PRELIMINARY MASTER PLAN

Draft Preliminary Master Plan

Preliminary Master Plan

Figure 9 – Draft Preliminary Master Plan

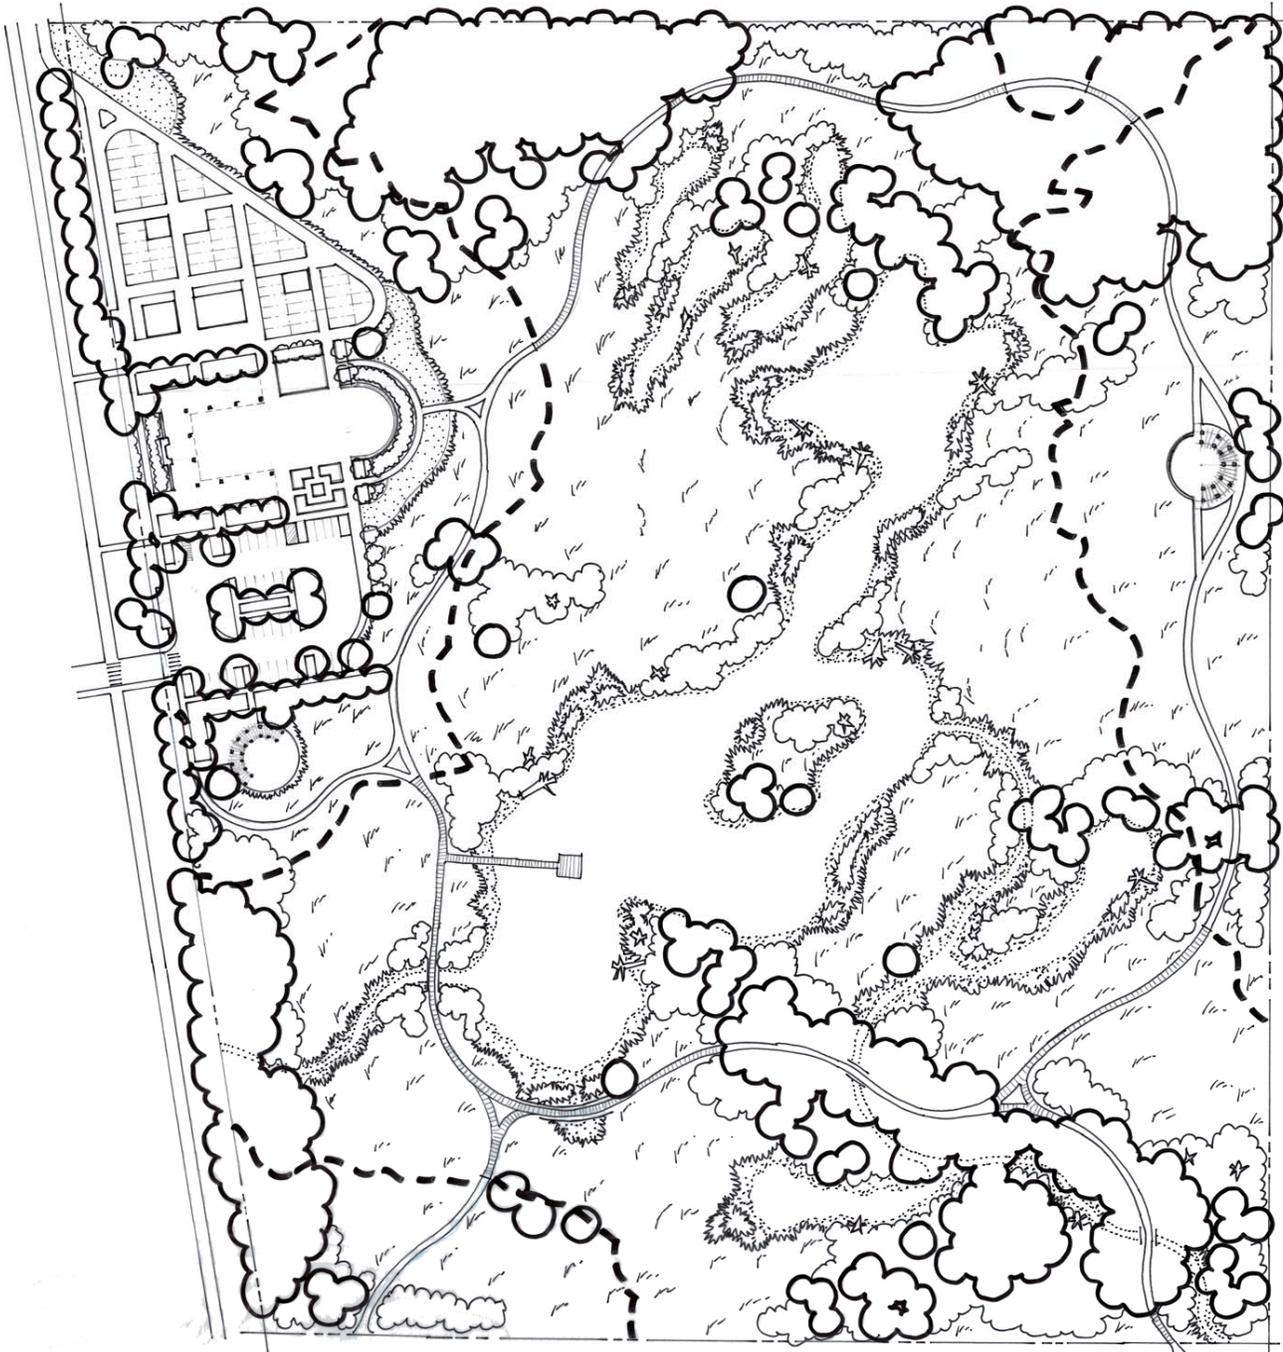
A draft of the Preliminary Master Plan was presented to city staff on November 12, 2009. Below is a summary of their comments:

- Increase parking if possible
- eliminating boat rental
- Add a small shelter at the west viewpoint location.
- Provide a community building that accommodates a preschool program, restrooms and a small staff office. Retain the breezeways if possible.
- Provide p-patch compost storage/potting/tool sharpening shed and a small shelter for gardeners
- Provide a connection from parking to p-patch along the west side of the community building.
- Provide a garden gateway in the southwest corner of the p-patch.
- Consider a less rectilinear layout of p-patch. Provide some curved pathways.
- Consider a storytelling areas arranged around a fire pit. The pit could have a lockable lid.
- Details and materials used in plaza should be of a high quality.
- This will be a gateway to the City. Pay attention to the west edge and the character seen from Willows Road.

- Provide wide spots along boardwalks for benches and interpretive signage
- Raise elevation of viewpoint on east side
- Maintain view corridors
- Maximize habitat diversity.
- Plan for eventual at-grade connection of creek to river through Button property.
- Keep ponds as deep as possible to maintain a layer of cool water.
- Keep the shoreline of ponds as long as possible with peninsulas, woody debris and snags.
- Keep shorelines of ponds shallow.
- Eliminate boat rental as program element.

The draft preliminary master plan design was refined based upon input received from city staff. No changes were made to the design between the Preliminary Master Plan and the Final Master Plan. The preliminary plan illustrations and description are the same as for the Final Master Plan. See Figures 10 and 11 and a description in the Final Master Plan chapter of this report.
